City of El Paso – City Plan Commission Staff Report

Case No: SUSU12-00071 Ventanas Subdivision Unit Six
Application Type: Major Preliminary
CPC Hearing Date: August 9, 2012
Staff Planner: Justin Bass, 915-541-4930, bassjd@elpasotexas.gov
Location: North of Ventana Ave and West of Rich Beem Blvd
Legal Description Acreage: 36.518 acres
Rep District: 6
Existing Use: Vacant
Existing Zoning: R-5 (Residential)
Proposed Zoning: R-5 (Residential)
Nearest School: Lujan Chavez Elementary School (1.49 miles)
Note: The Ventanas Land Study - which includes this subdivision - identifies a future school site for the property directly south of this subdivision.
Nearest Park: Unnamed Park (0.16-mile)
Parkland Fees Required: N/A
Impact Fee Area: This property is not located within an Impact Fee Service Area and is not subject to impact fees.
Property Owner: GFA, LLC
Applicant: CEA Group
Representative: CEA Group

ATTACHMENT 4

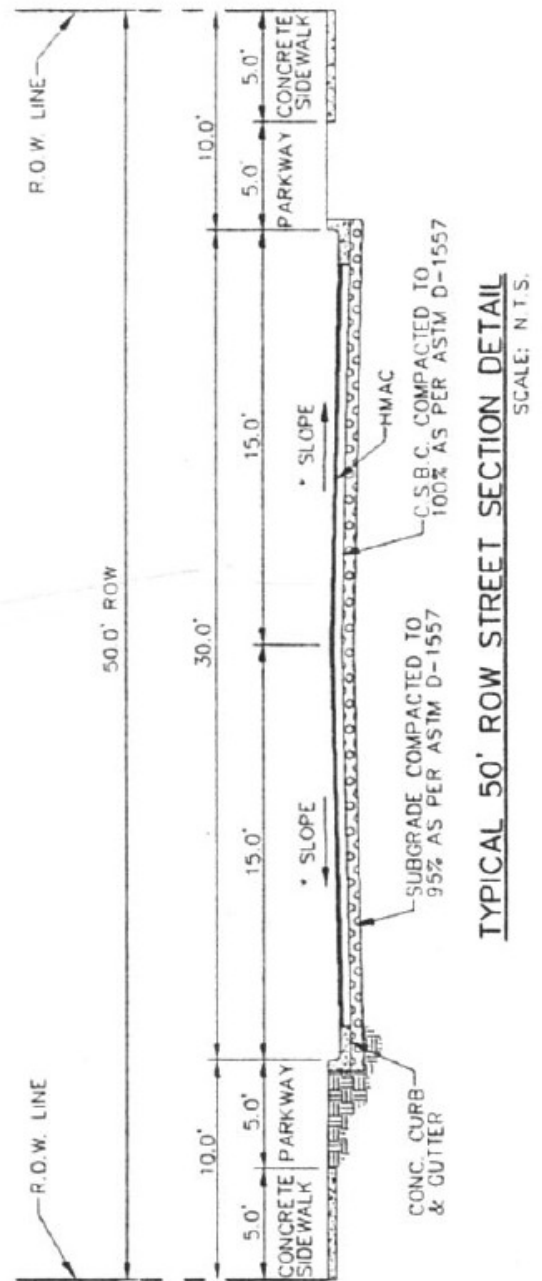
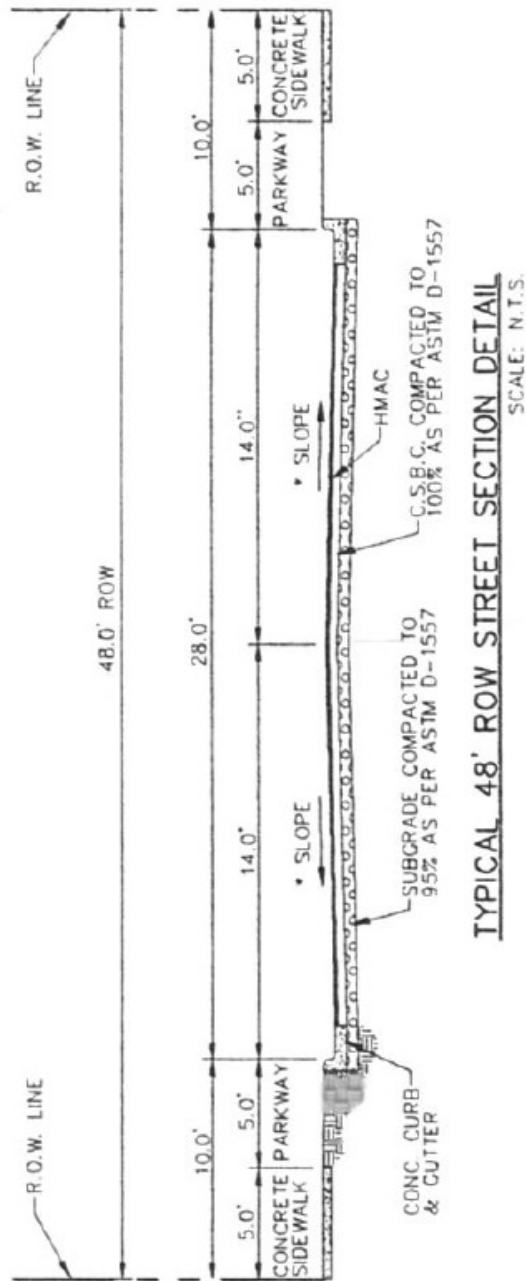
- To allow for the reduction of street right-of-way from 52-ft to 50-ft. The cross-section

will consist of 5-ft sidewalks, 5-ft parkways, and 30-ft of pavement, with a standard concrete curb and gutter.

- To allow for the reduction of street right-of-way from 52-ft to 48-ft. The cross-section will consist of 5-ft sidewalks, 5-ft parkways, and 28-ft of pavement, with a standard concrete curb and gutter.
- To allow for a street name longer than 13 characters.

The Development Coordinating Committee recommends ***approval*** of the modifications under Reason 3 of Section 19.04.170.A of the previous Subdivision Ordinance and ***approval*** of Ventanas Subdivision Unit Six on a **Major Preliminary** basis subject to the following conditions and requirements:
